#### **Addendum 28 – UN Regulation No. 29**

#### **Revision 2 - Amendment 4**

#### **Uniform provisions concerning the approval of vehicles with regard to the protection of the occupants of the cab of a commercial vehicle**

"Figure 1  
Front impact test and front pillars impact test  
The cab is mounted on the vehicle

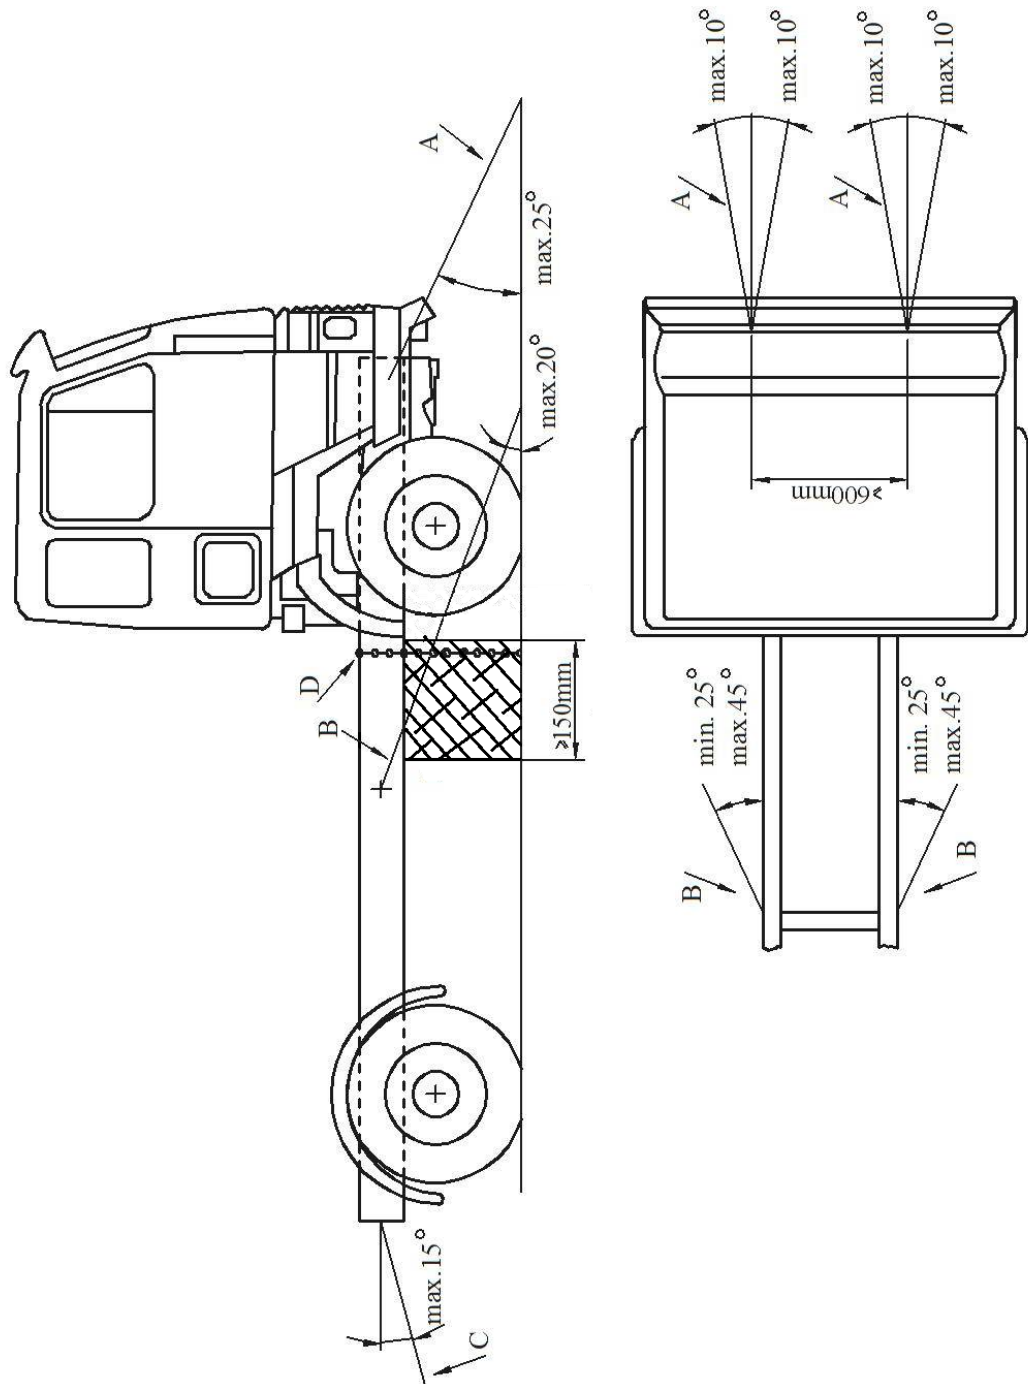
*Figure 1*, shall be deleted

Insert new Figures 1 and 2, to read:

Lateral movement shall be limited by chains or ropes B attached to the chassis frame symmetrically in relation to its longitudinal axis. The points of attachment to the chassis shall be not more than 5 m and not less than 3 m from the front of the vehicle. The chains or ropes shall when tensioned form a downward angle of not more than 20° with the horizontal and their projection on a horizontal plane shall form an angle of not less than 25° and not more than 45° with the longitudinal axis of the vehicle (see Figure 1 below).
  - 2.2. Cab mounted on a frame

Lateral movement shall be limited by chains or ropes B attached to the chassis frame symmetrically in relation to its longitudinal axis. The points of attachment to the chassis shall be not more than 5 m and not less than 3 m from the front of the vehicle. The chains or ropes shall when tensioned form a downward angle of not more than 20° with the horizontal and their projection on a horizontal plane shall form an angle of not less than 25° and not more than 45° with the longitudinal axis of the vehicle (see Figure 1 below).
  - 3.2. Cab mounted on a frame
